BLACK ARROYO DAM

SITE DEVELOPMENT PLAN FOR SELF STORAGE FACILITY

RESPONSE FOR COMPLIANCE TO "CONDITIONS" OF E.P.C. APPROVAL OF SITE PLAN FOR BUILDING PERMIT.

SITE DEVELOPMENT PLAN FOR BUILDING PERMIT

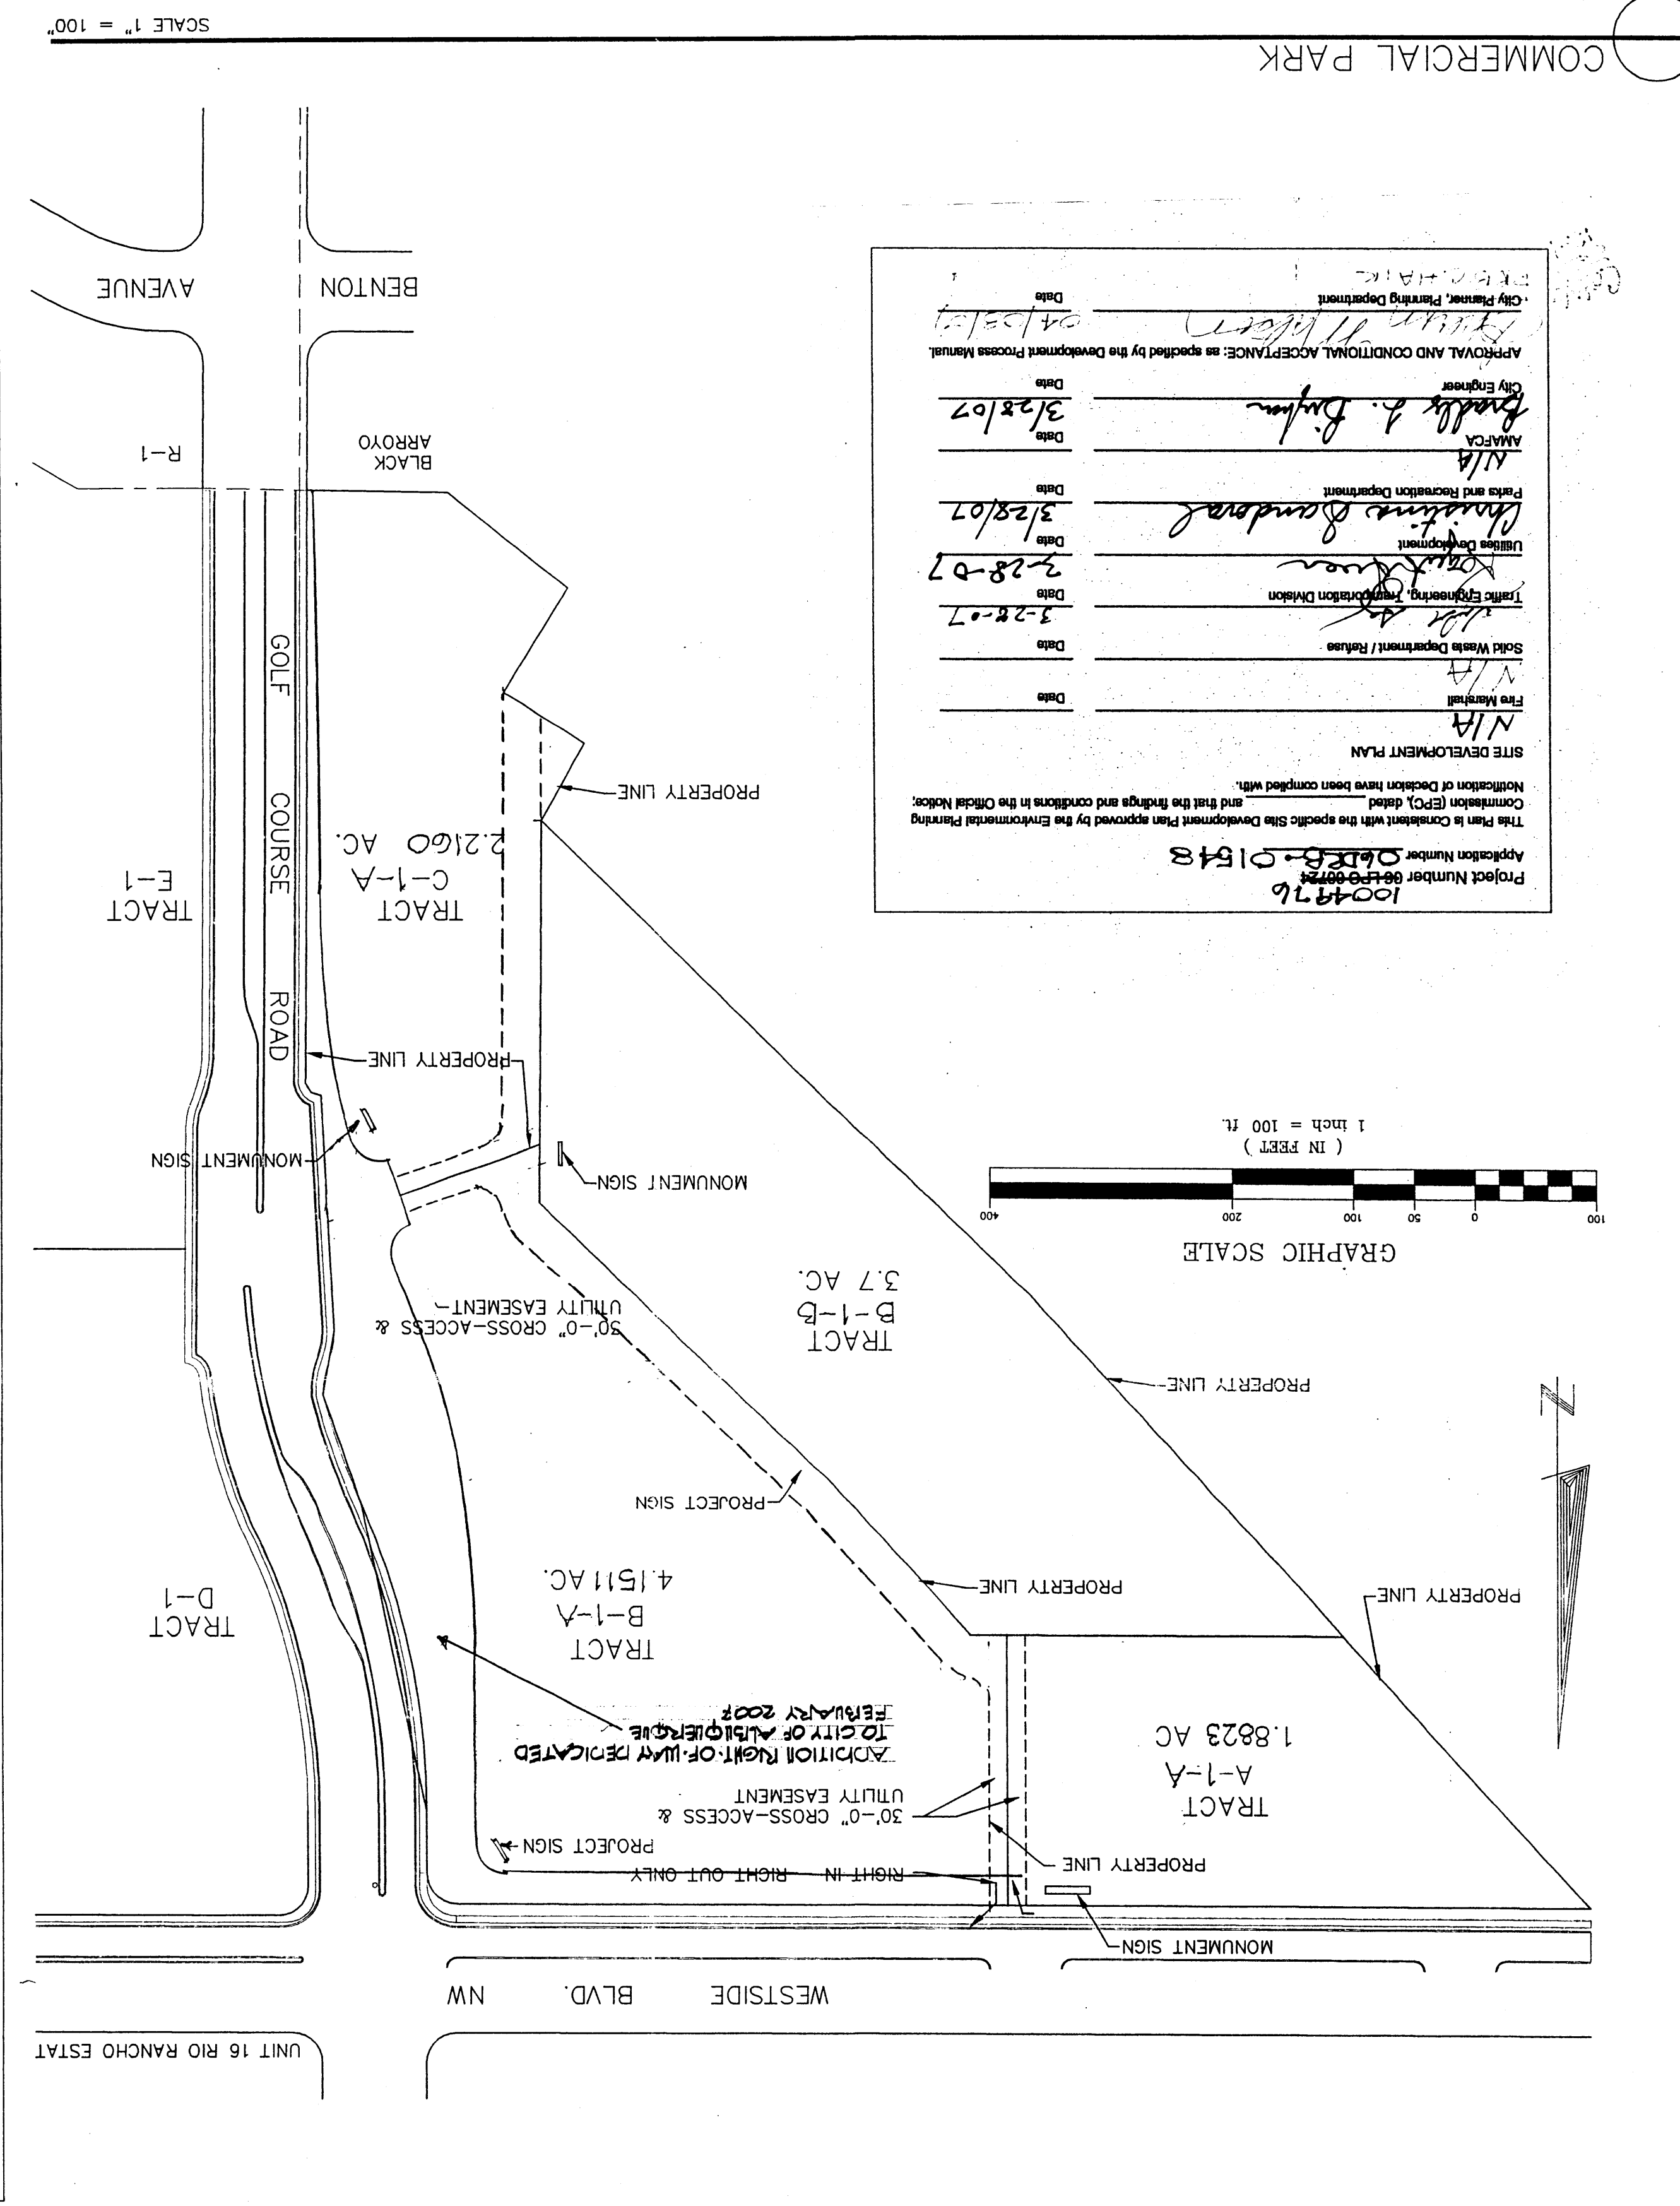
1. THE FOLLOWING SHALL BECOME AN INTEGRAL PART OF "SITE PLAN FOR BUILDING PERMIT."
2. WALLS AND FENCES:
 - A) THE CMU WALL AROUND THE REFUSE ENCLOSED SHALL BE SIX FEET FROM FINISH GRADE TO TOP OF THAT WALL.

- B) PILASTERS, EVERY 20 FT. SHALL BE ADDED TO THE WALL TO IMPROVE ITS QUALITY AND LESSEN THE FORTRESS FEELING.
 - C) PATIO FENCED AROUND THE CARETAKERS YARD SHALL BE LIGHT TAN CMU BLOCK.

- D) THE CHAIN LINK FENCE SURROUNDING THE PHASE II FUTURE DEVELOPMENT SHALL BE REMOVED 3 YEARS FROM SEPTEMBER 21, 2006
 - E) THE CHAIN LINK FENCE SHALL EXTEND TO THE BUILDING AND STOP, AND THE BUILDING CAN BE USED AS A BOUNDARY - LEAVING THE 6 FT. DRAINAGE CHANNEL FREE AND USING LESS FENCING.

3. THE LIGHTING HAS BEEN ADDRESSED ON THE ELEVATIONS SHEET, ELEVATION AT TYPICAL GARAGE DOORS OF THE PREFAB STORAGE UNITS.
4. PEDESTRIAN AND BICYCLE ACCESS AND CIRCULATION: PEDESTRIAN AND BICYCLE ACCESS AND CIRCULATION IS NOT A REQUIREMENT OF THIS SPECIFIC PROJECT BECAUSE SELF-STORAGE IMPLIES TRANSPORTING ITEMS IN AND OUT OF THE UNITS USING A CAR OR A TRUCK.

5. MOTORCYCLE AND BICYCLE PARKING IS NOT REQUIRED FOR THE REASON STATED IN THE ABOVE NOTE.
6. THE ADDITIONAL LANDSCAPING HAS BEEN ADDED. SEE REVISED SITE PLAN.
